### PRODUCT/PROCESS CHANGE NOTICE (PCN)

PCN #: **TB0605-07**                              DATE: **7/01/06**  
Product Affected: **Freescale CABGA 100L Products**  
**shipped in tray**  
Date Effective: **7/31/06**

### ATTACHMENT I - PCN #: TB0605-07

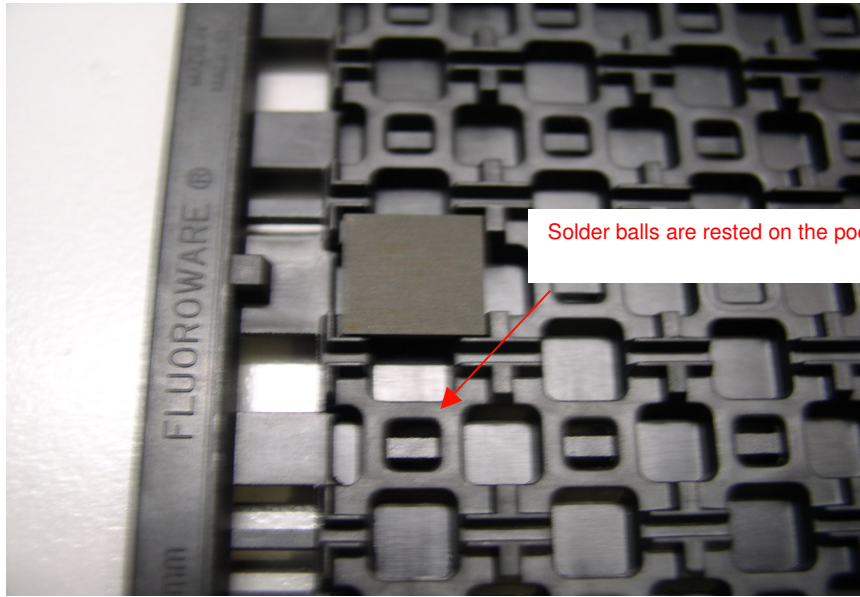
**Detail of Change:** IDT will change the shipping tray vendor from Fluoroware to Daewon for the CABGA 100L products after completion of the qualification.

The reason for change is to provide better protection to the package. The existing tray has pocket design, which bring solder balls in contact with tray pocket when a unit is seated on the tray pocket. The newly improved tray is designed in such a way that solder balls are not contacting with any part of the tray pocket when unit is seated. The advantages are to eliminate potential quality issue like dented solder ball or contaminated solder ball.

Description	Existing Shipping Tray	New Shipping Tray
Supplier	Fluoroware	Daewon
Part Number	41111-11-0822-9	12C-1111-E19
Tray Matrix	8x22	8x21
Qty per Tray	176 units	168 units
Pocket Size (WxL)	11.23x11.23 +/-0.08mm	11.17x11.17 +/-0.08mm
